# Test Fixture Delay (Comment #110/#111/#112/#113)

IEEE P802.3ck Task Force Interim Meeting  
July, 2020

# Tfx value vs Differential TDR of MCB and HCB

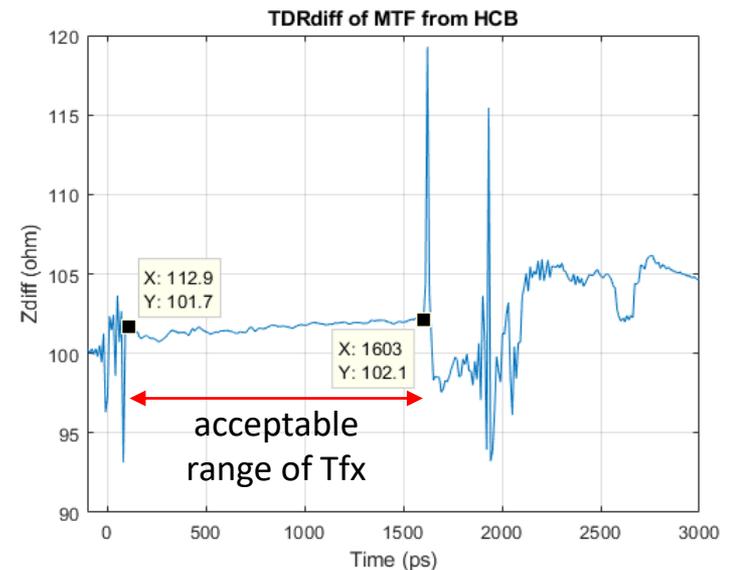
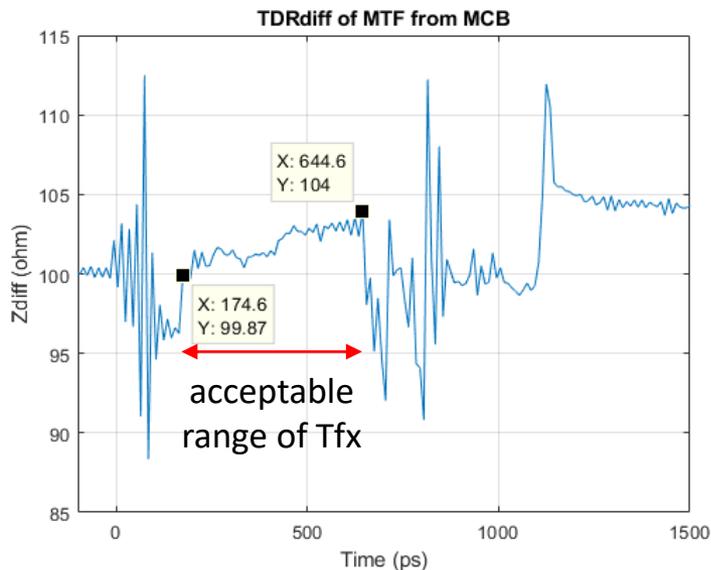
"The beginning of the host connector" is not clear.

Where is “the beginning of the host connector”?

- Below are differential TDR of OSFP Mated Test Fixture transformed from measured S-parameters contributed by Sam Kocsis (Amphenol) to Task Force (kocsis\_3ck\_02\_0719\_MTFospf.zip).
- The optimal Tfx value may be about 640ps (MCB, left) or 1600ps (HCB, right), close to the end of flat impedance range. However, this point is difficult to define without ambiguity.
- Since **Nbx is 0 in Annex 120G and Clause 162**, optimization of Tfx is not important. Any Tfx value is acceptable between 175ps and 640ps (MCB, left) or between 113ps and 1600ps (HCB, right), because ERL will be similar for any Tfx value in this range of flat impedance.
- **200ps seems enough for various possible MCB and HCB designs** to mask the initial impedance discontinuity due to coax connector etc. A fixed Tfx value is fair and eliminates ambiguity.

Change the text “The value of Tfx is twice the delay from the measurement point TP1a to the beginning of the host connector.” to

“The value of Tfx is 0.2 ns representing twice the transmission line delay which sufficiently mitigates the test point and transmission line return loss.”

# Tfx value vs ERL

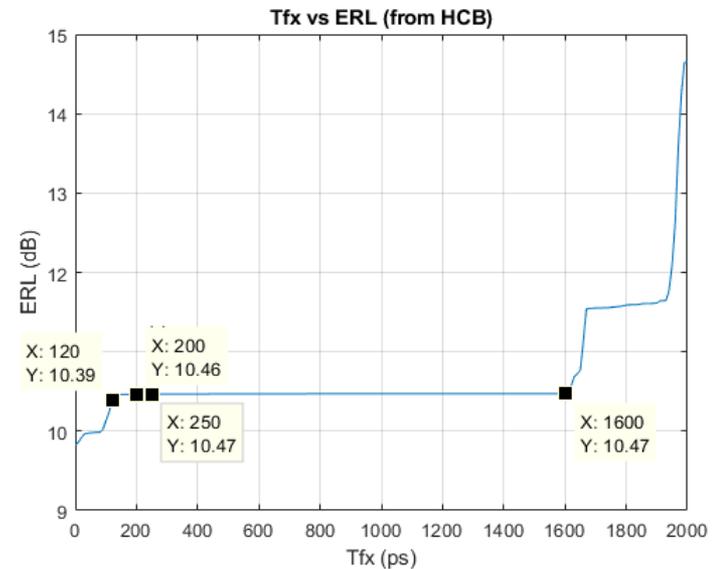
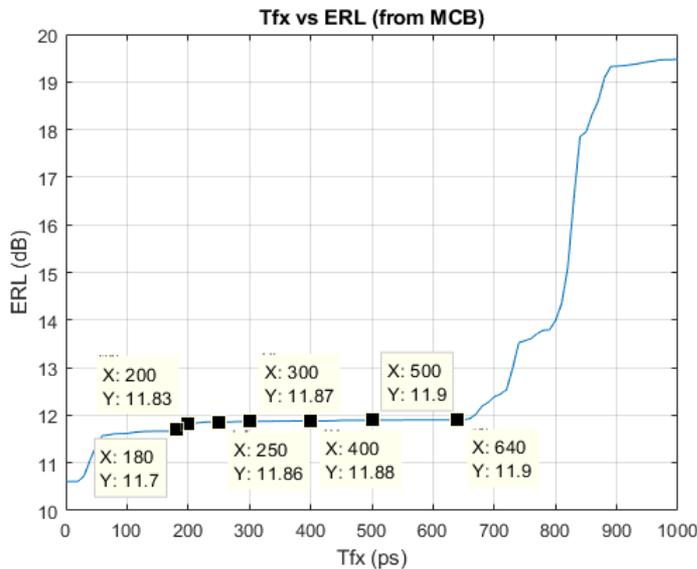
- Degradation of ERL by non-optimal Tfx value is less than 0.1dB.
- We may choose 250ps or 300ps, but too high Tfx value may introduce a chance of being unfair, because someone may use an ultra short test fixture (with lossy material to meet IL requirement).
